# RENESAS TECHNICAL UPDATE

Product Category	MPU/MCU		Document No.	TN-RX*-A040A/E	Rev.	1.00
Title	Errata to RX210 Group User's Manual: Hardware		Information Category	Technical Notification		
Applicable Product	RX210 Group	Lot No.	Reference Document	RX210 Group User's Manual: Hardware Rev.1.10 (R01UH0037EJ0110)		
		All

This document describes corrections to RX210 Group User's Manual: Hardware Rev.1.10.

Figure 28.69 Example of Flowchart for Transition to Software Standby Mode during Transmission

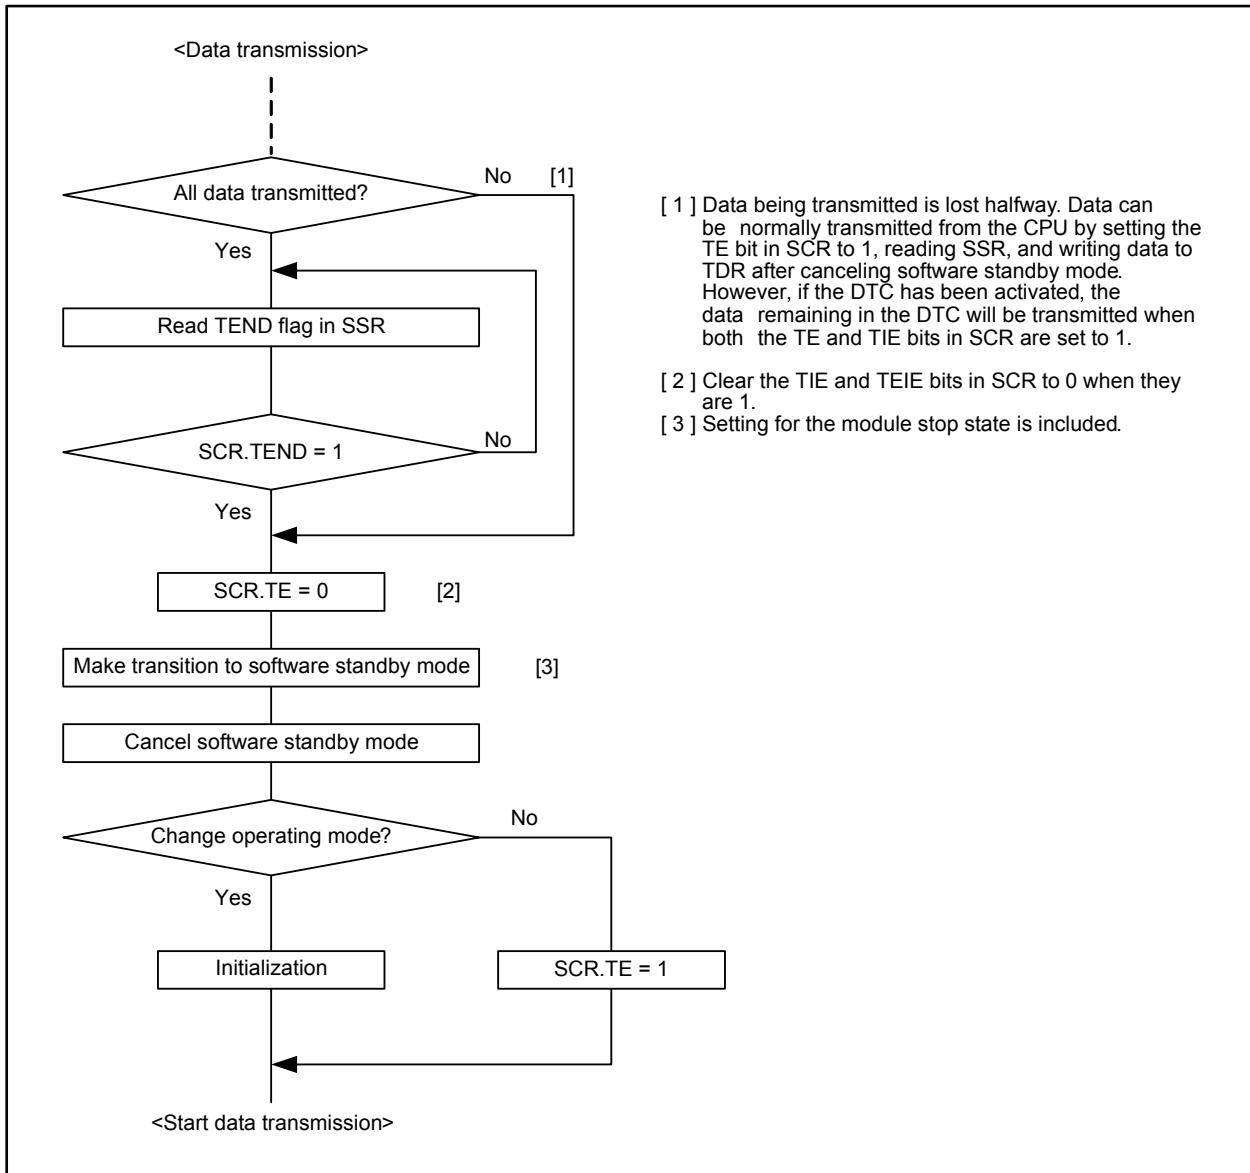
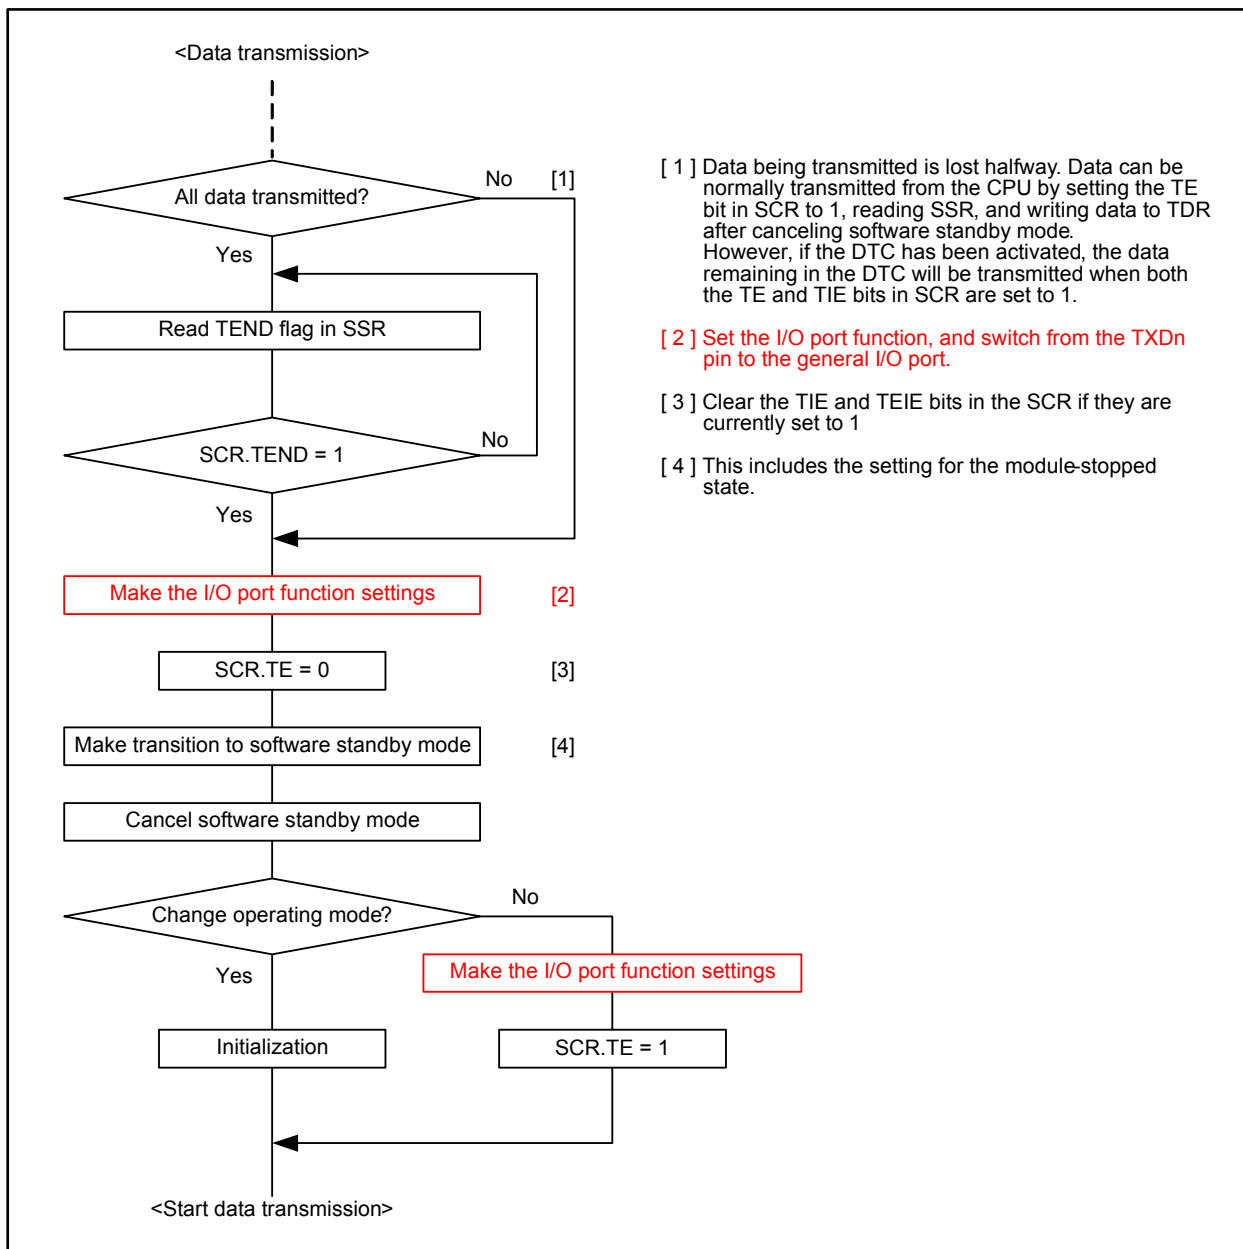
Step [2] is added to Figure 28.69 as follows:

- [ 1 ] Data being transmitted is lost halfway. Data can be normally transmitted from the CPU by setting the TE bit in SCR to 1, reading SSR, and writing data to TDR after canceling software standby mode. However, if the DTC has been activated, the data remaining in the DTC will be transmitted when both the TE and TIE bits in SCR are set to 1.
- [ 2 ] Clear the TIE and TEIE bits in SCR to 0 when they are 1.
- [ 3 ] Setting for the module stop state is included.
